**NEW YORK STATE THRUWAY AUTHORITY
DEPARTMENT OF ENGINEERING**

**AMENDMENT NO. 2
TO**

**CONTRACT TAN 24-12
D214948
PAVEMENT REHABILITATION AND
MISCELLANEOUS WORK ON
I-190, NIAGARA THRUWAY
FROM MP N0.7 to MP N4.2
IN THE BUFFALO DIVISION
OF THE NEW YORK STATE THRUWAY
IN ERIE COUNTY**

TITLE OF PROJECT I-190 HIGHWAY REHABILITATION	CONTRACT NUMBER: TAN 24-12
LOCATION OF PROJECT I-190 NIAGARA THRUWAY MP 900.7 TO MP 904.2	DATE: JUNE 2024
TITLE OF DRAWING TRAFFIC CONTROL DETAILS	DRAWING NUMBER: TCP-2

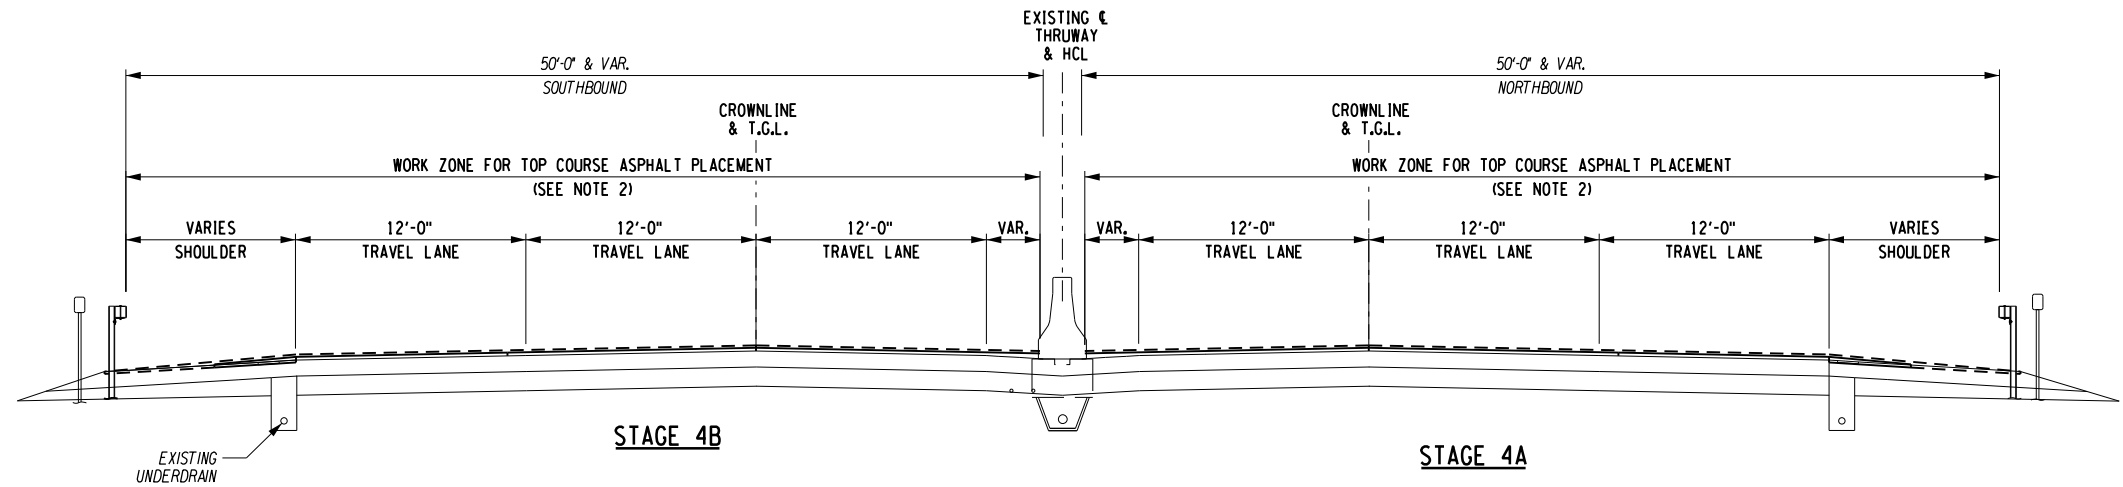
4. **DELETE** Drawing Number TCP-2, Sheet 24 of 274, and **SUBSTITUTE** with the attached Drawing Number TCP-2, Sheet 24-A2. Note Number 2 has been rewritten and it now states that just one course overlay across all lanes for the entire length of asphalt placed in one working day will be required, instead of two courses.

- NOTES:**
1. THE LONG TERM RIGHT LANE CLOSURE SHALL BE IN PLACE UNTIL THE COMPLETION OF STAGES 1C AND 2C OR ABOVE UNLESS OTHERWISE APPROVED BY THE ENGINEER. WORK AREAS ON OPPOSITE SIDES OF THE ROAD SHALL NOT OVERLAP OR CO-EXIST.
 2. STAGE 4 ASPHALT PAVEMENT SHALL BE PLACED USING SHORT-TERM LANE CLOSURES IN ACCORDANCE WITH THE "LANE CLOSURE CHARTS" ON NYSTA STANDARD SHEETS TA 619-37. ONE LANE OF TRAFFIC MUST BE OPENED AT ALL TIMES. THE CONTRACTOR MUST PLACE ONE COURSE OF THE OVERLAY ACROSS ALL LANES FOR THE ENTIRE LENGTH OF ASPHALT PLACED IN ONE WORKING DAY.
